Subject: **Request for Section 404 Individual Permit and Section 401 Water Quality Certification Modification** for the widening of NC 49 from East of NC 73 to East of SR 2630 (Cline Road) in Cabarrus County. Federal Aid Project No. NHS-0049(26), Division 10, TIP No. R-2533CC.

Reference: USACE Individual Permit Action ID SAW-2010-00726, dated June 6, 2011.
NCDWQ Water Quality Certification No. 003847, dated January 19, 2011.

Permit Drawing
 Sheet 6 of 40
 revised 1/17/12

Permit Drawing
 Sheet 36 of 40
 revised 11/1/12

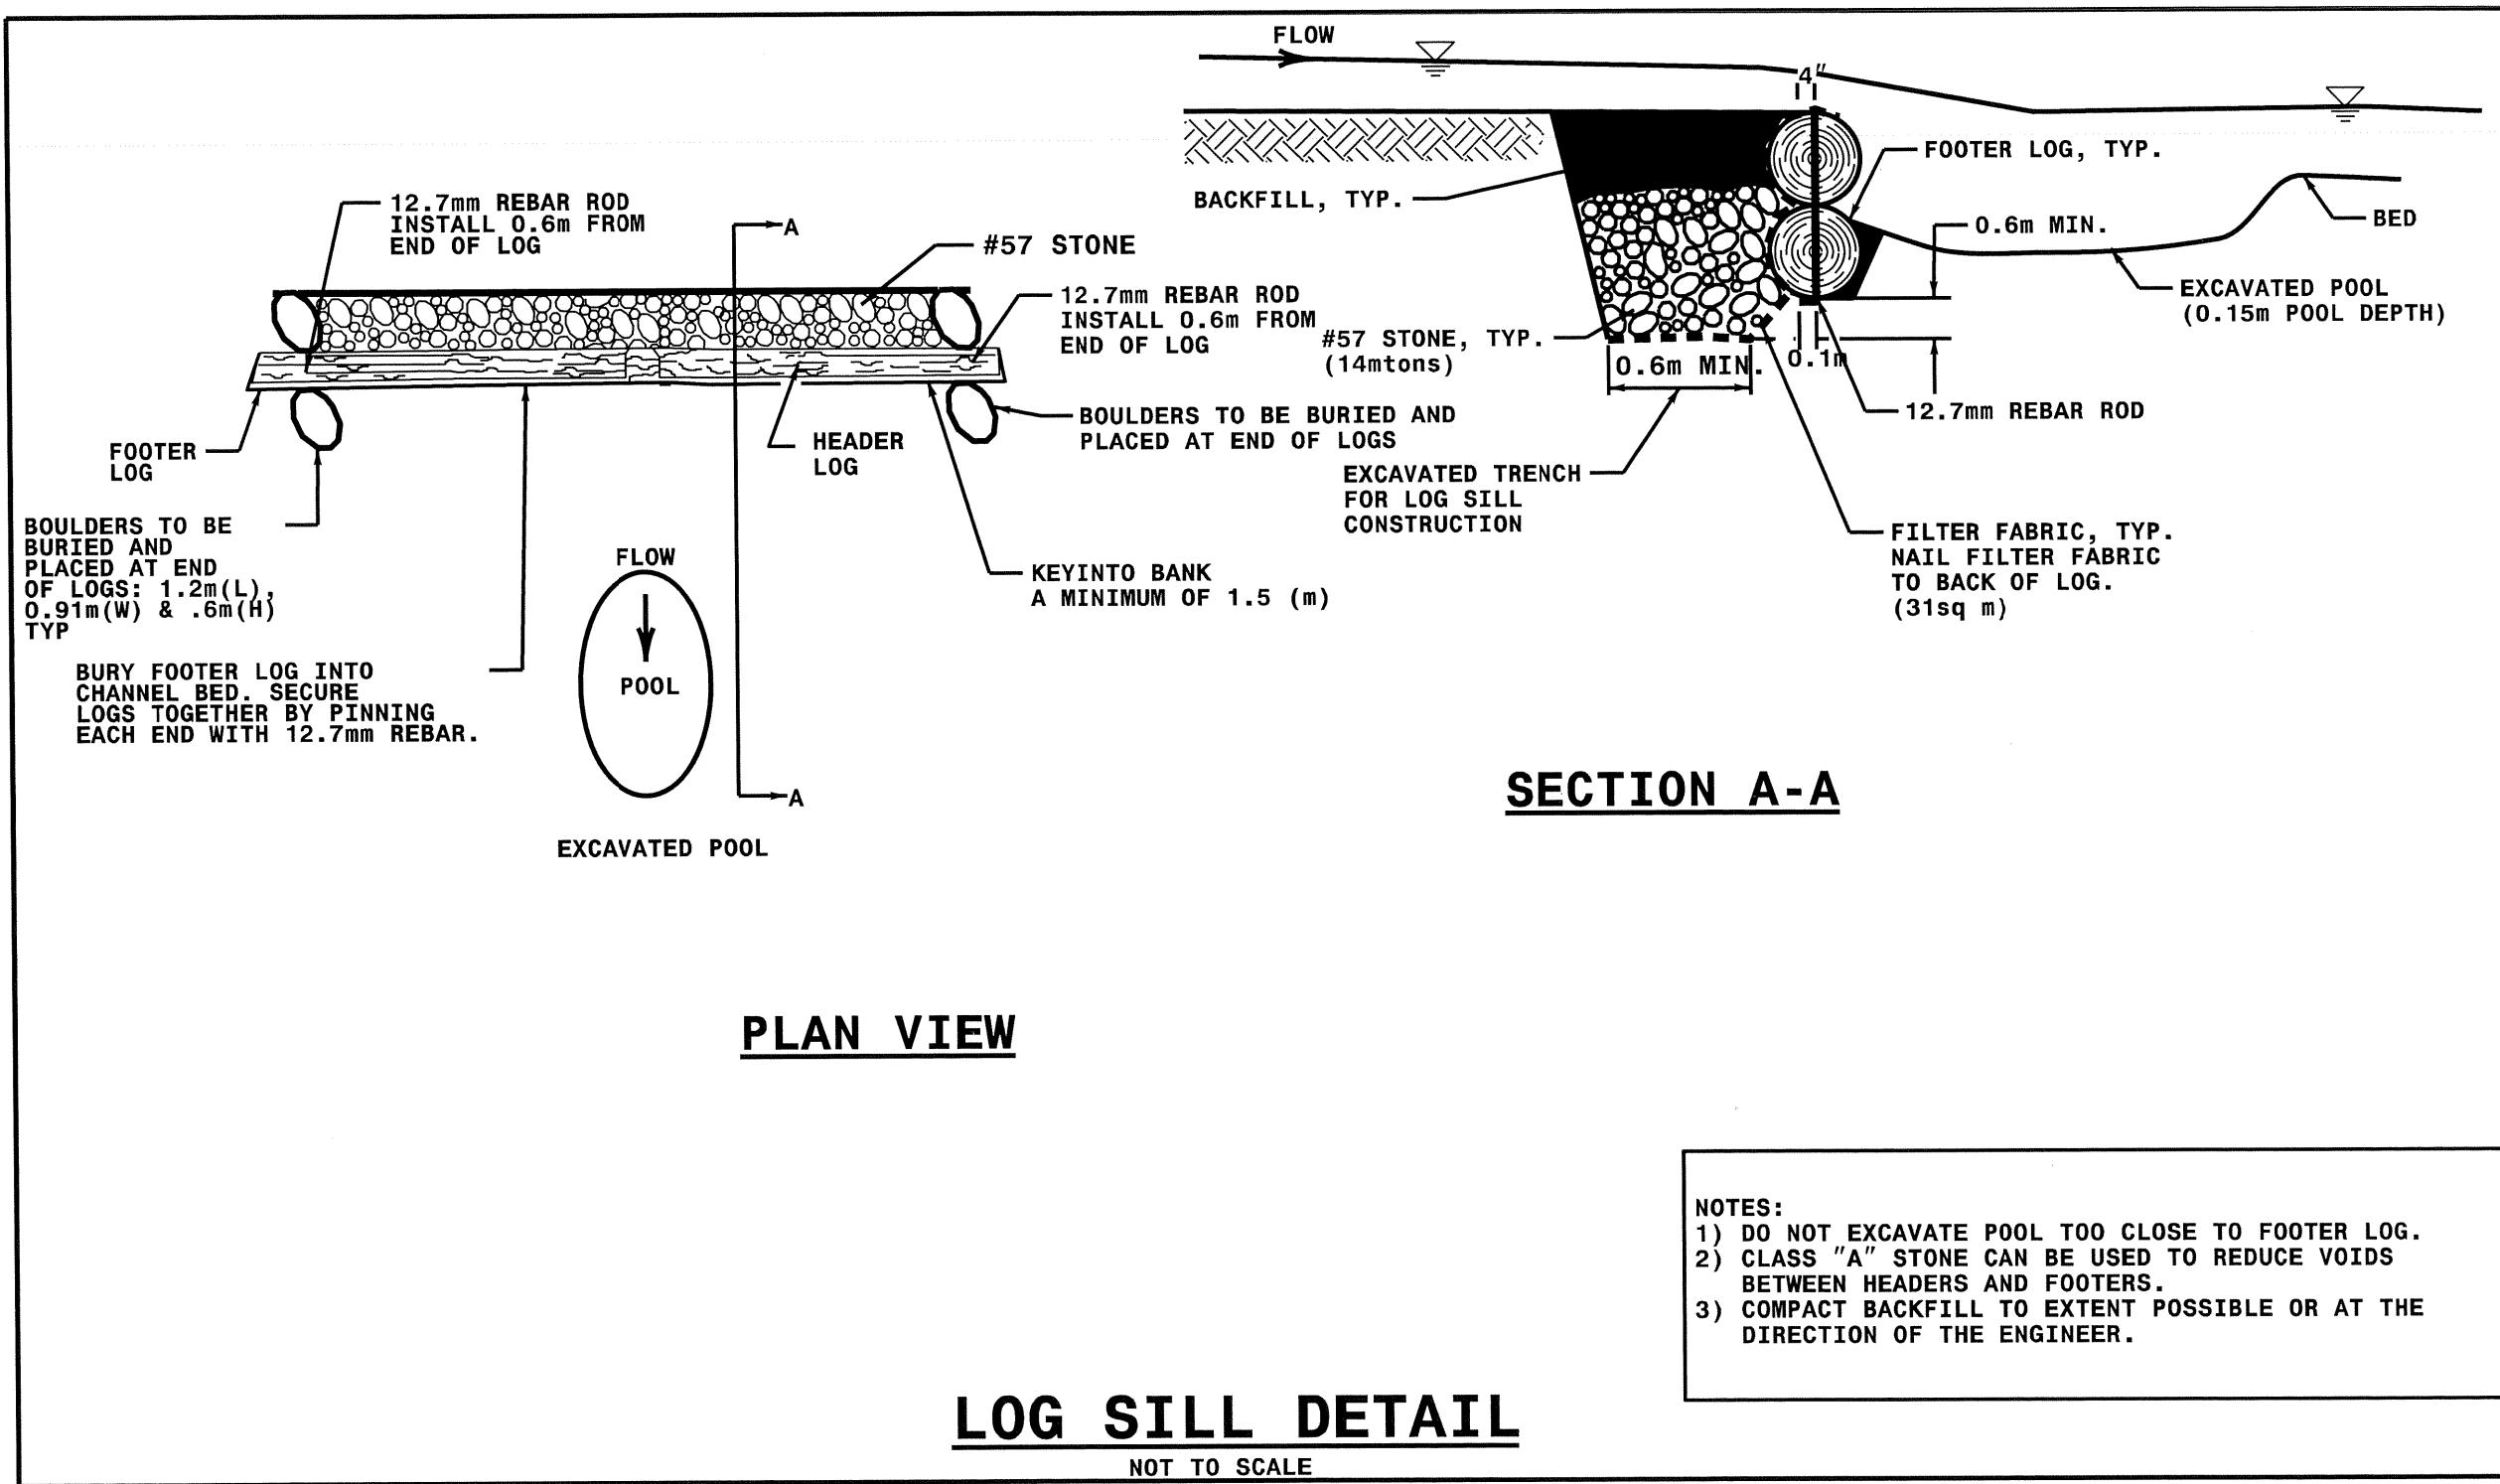
The addition of the log sill at Site 7 will cause 26 feet of permanent stream impact due to the installation of the pipe. The area impacted will occur in an area where temporary impacts

were to already occur. The attached wetland summary sheet reflects the changes in impacts at this site. The design for the placement of the log sills has been discussed and approved by the USACE and NCDWQ. The USACE has determined that no new mitigation would be required for this work.

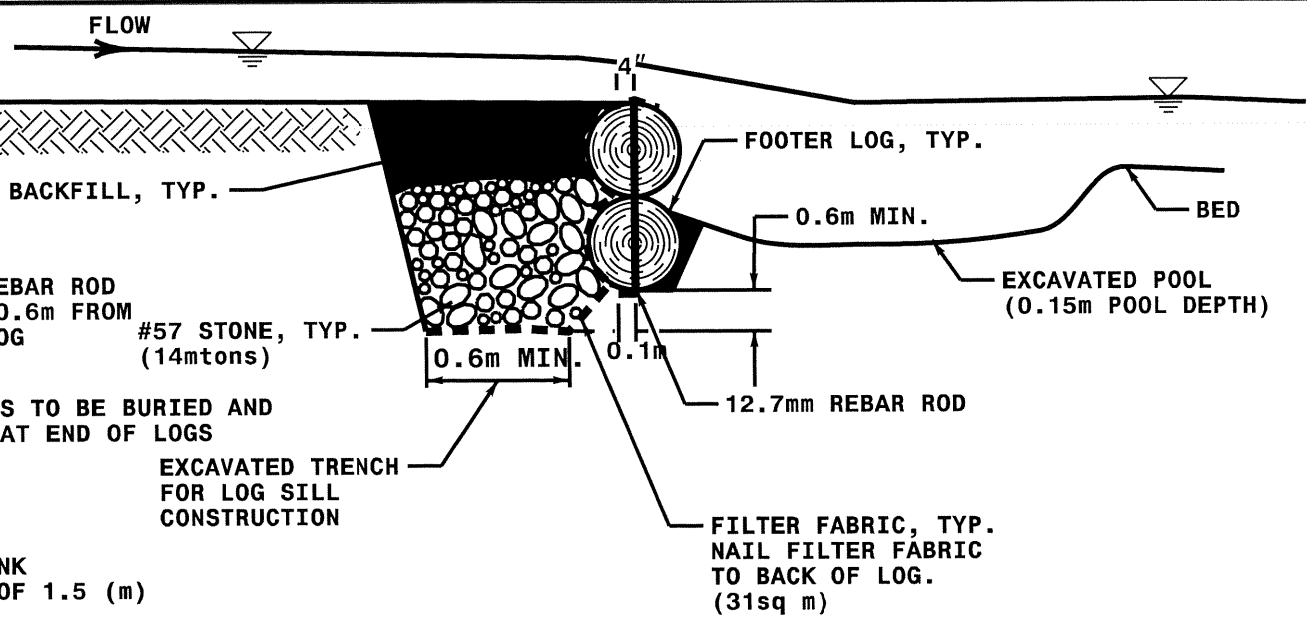
The purpose of this letter is to request a modification to the United States Army Corps of Engineers (USACE) Individual Permit and North Carolina Division of Water Quality Certification for the above referenced project. The requested modification is to rectify problems that have occurred during the placement of a 1650 mm RCP at Site 7. Currently there is a considerable elevation difference between the undisturbed portion of the stream and the pipe inlet. There is approximately 2.85 feet of fall occurring within the approximate 26 feet of stream as it enters the pipe. NCDOT proposes to rectify this problem by installing a log sill in the area of the stream before it enters the pipe. The log sill will be used to direct the stream flow (thalweg) toward the center of the channel and to provide grade control. The log sill will be constructed of hardwood tree species with a minimum diameter of 12-inches. The length of each log shall be sufficient to allow proper construction and so they can be keyed into the banks a minimum of 1.5 meters (approx. 5 feet).

KEY INTO BANK
 A MINIMUM OF 1.5 (m)

BOULDERS TO BE
 BURIED AND
 PLACED AT END
 OF LOGS: 1.2m(L),
 0.91m(W) & .6m(H)
 TYP

BURY FOOTER LOG INTO
 CHANNEL BED. SECURE
 LOGS TOGETHER BY PINNING
 EACH END WITH 12.7mm REBAR.
